Serial No. 11-616
NSS&L/MLC R0
Docket No. 50-423
License No. NPF-49

DOMINION NUCLEAR CONNECTICUT, INC.
MILLSTONE POWER STATION UNIT 3
CORE OPERATING LIMITS REPORT, CYCLE 15

CORE OPERATING LIMITS REPORT, CYCLE 15

MILLSTONE UNIT 3

Figure 4 Required SHUTDOWN MARGIN for MODE 5 with RCS Loops Filled

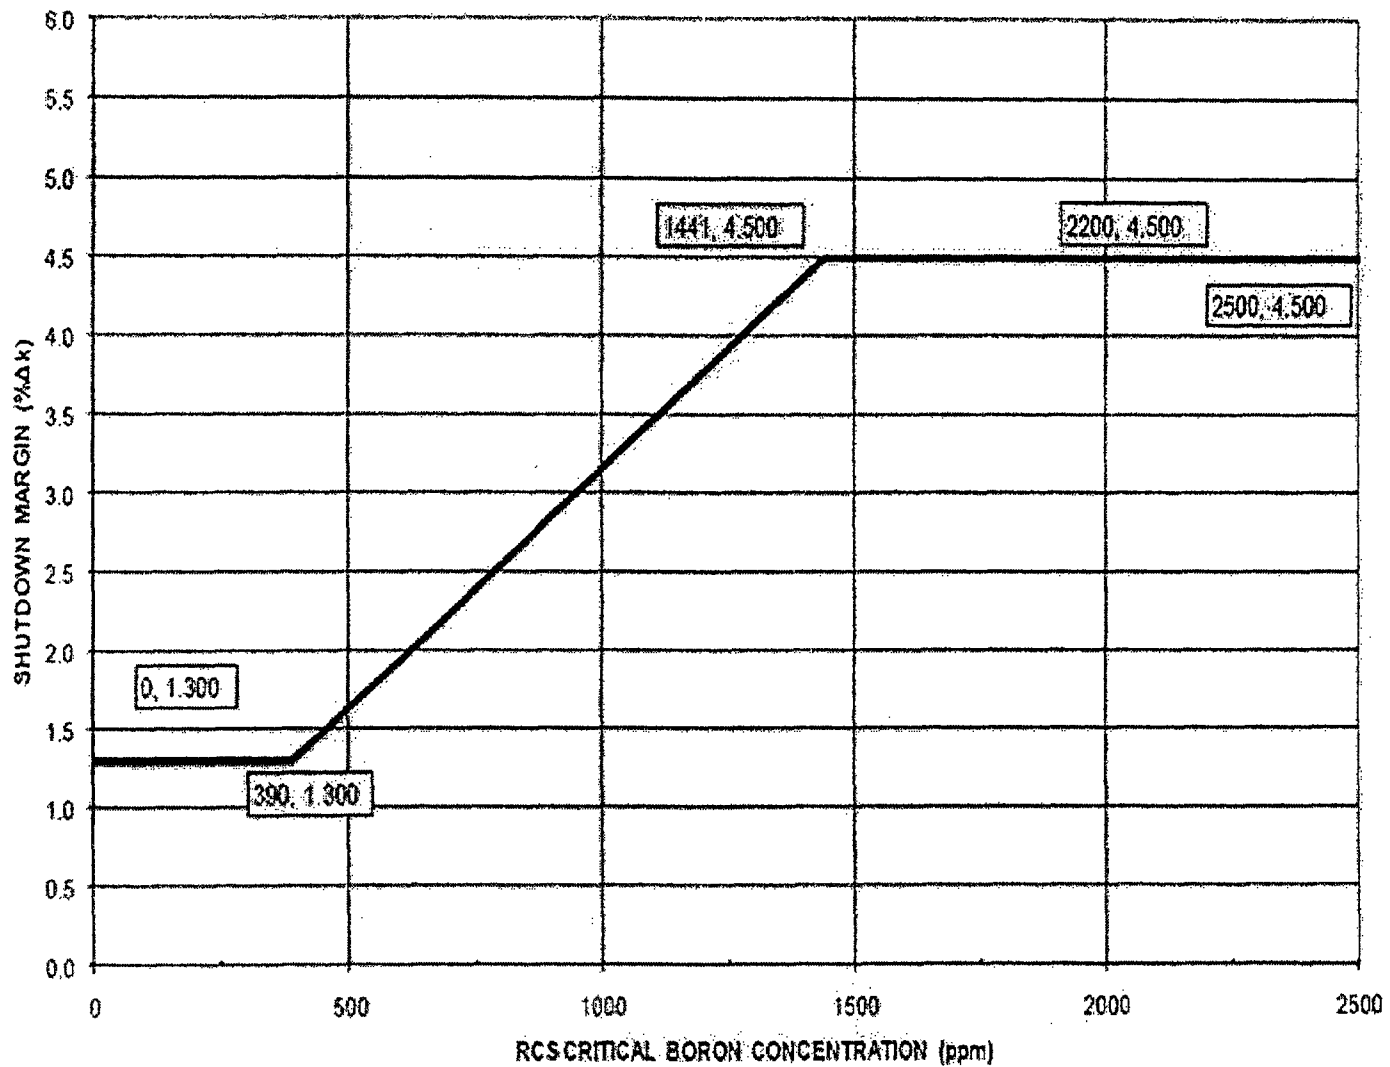
- Editorial changes to increment the cycle number from 14 to 15.
- Revision of the MODE 5 (with RCS loops filled) shutdown margin requirements in Figure 4 to support Cycle 15 conditions.
- Cycle 15-specific changes to the W(Z) values in Tables 1 through 3.
- Revision of the burnup penalties for incore measurements in Table 4 to support Cycle 15 conditions.
- Editorial change to Reference 3.6 to correct a typographical error.
- Editorial change to the title name of Table 4 on Pages 8.1-3 and 8.1-24.
